ADDENDUM NO. 2

WAYLAND HIGH SCHOOL ATHLETIC FIELD BUILDINGS Wayland, MA

IFB #20-1012

August 19, 2019

TITLE: PROCEPTOR® F.O.G. SEPARATOR
 GMC 100

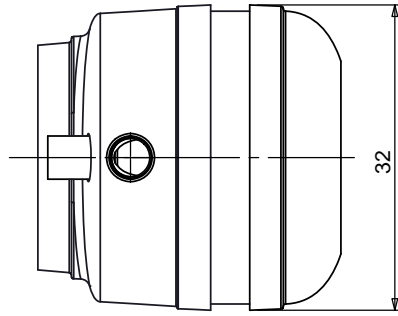
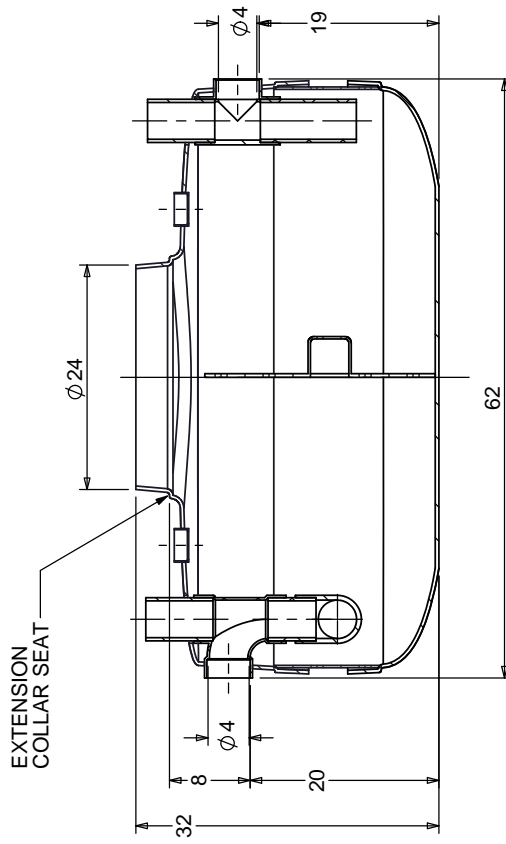
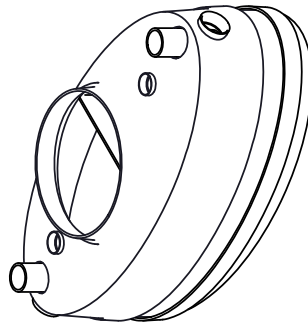
1. **Question:** Who is responsible for the grease interceptor?

Response: The Plumbing Contractor shall be responsible for providing the grease interceptor model number GMC 100 as manufactured by Zurn Industries, LLC, 511 W. Freshwater Way, Milwaukee, WI 53204, 855-663-9876, per attachment.
